Name of Proposal: RC-18-02CC Lee Industrial Drive

Review Type: Metro River

Date: February 9, 2018
To: File
From: Jim Santo 
Subject: Explanation of the Equivalent Consistency Finding for the Replacement of Navigation Equipment for Runway Approach to Fulton County Airport in Cobb County Metro River Review

---DRAFT---
IMPERVIOUS AREA INSIDE 150' BUFFER,
COBB COUNTY SIDE

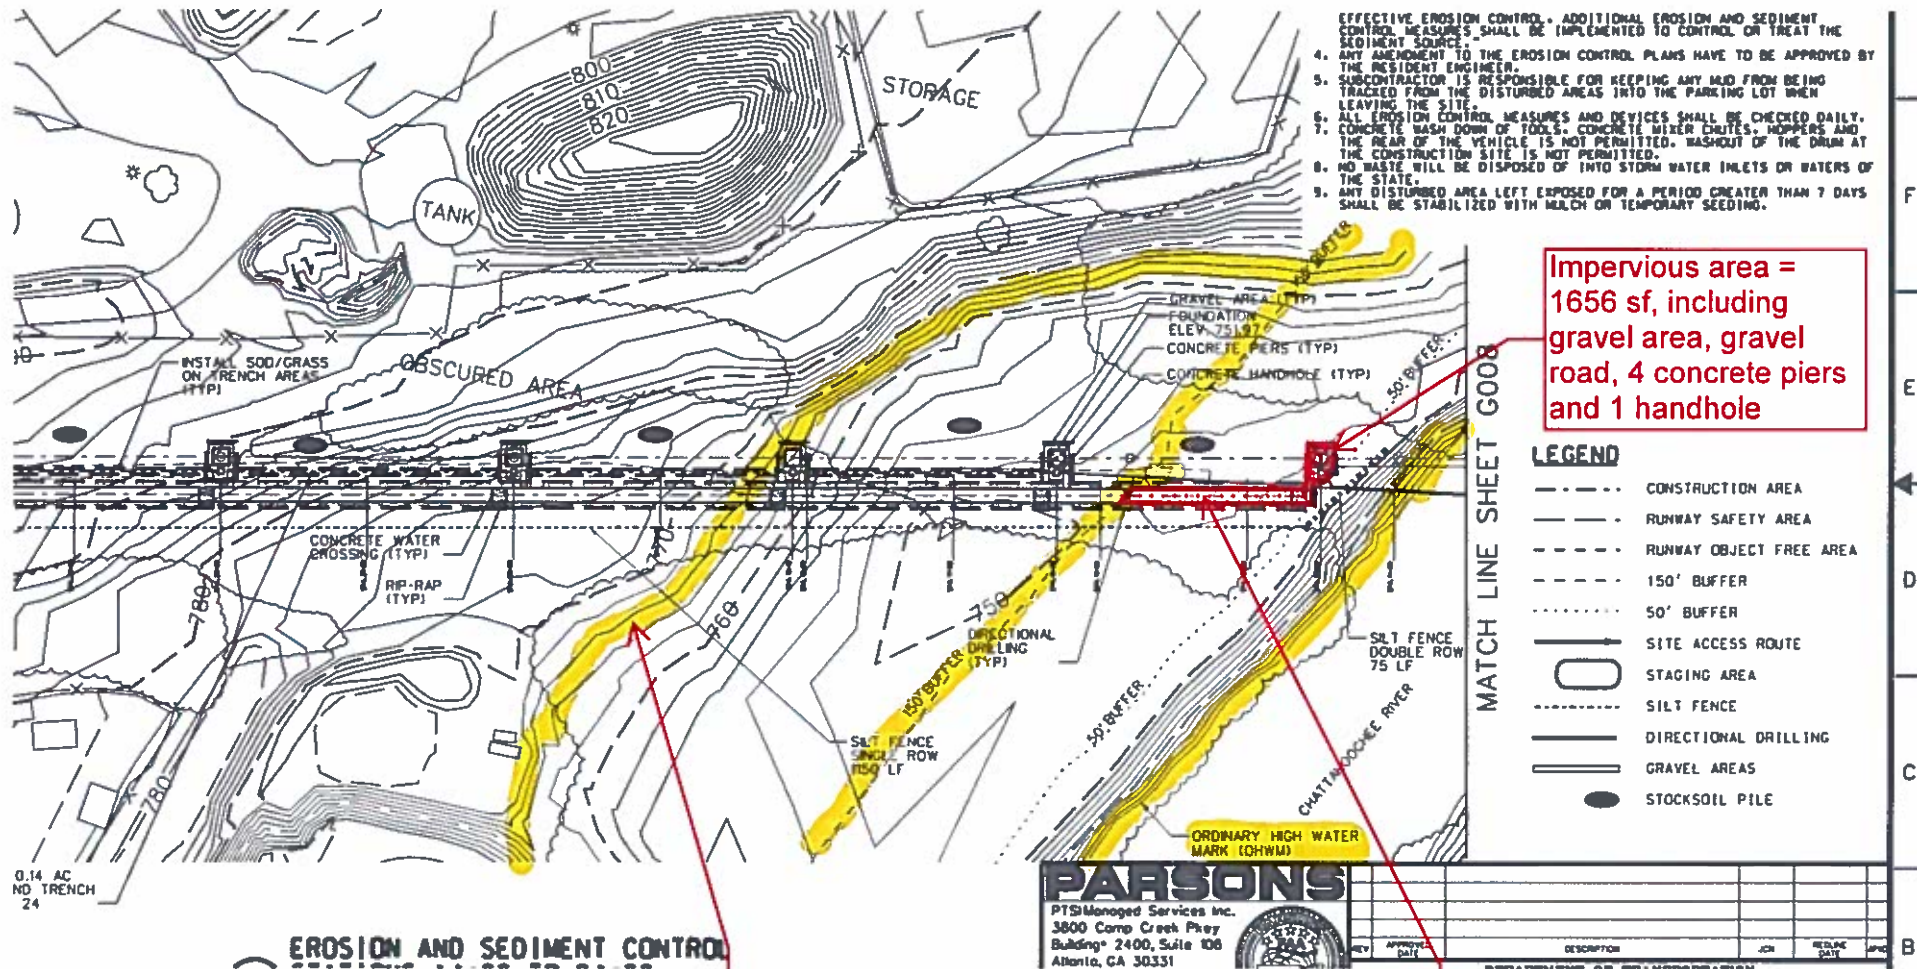
Impervious area =
1656 sf, including
gravel area, gravel
road, 4 concrete piers
and 1 handhole

if we remove the gravel road inside the buffer and gravel area around
foundation we will have only the four 1.5'x1.5' concrete piers and a
4'x4' concrete handhole, then new impervious area = 25sf
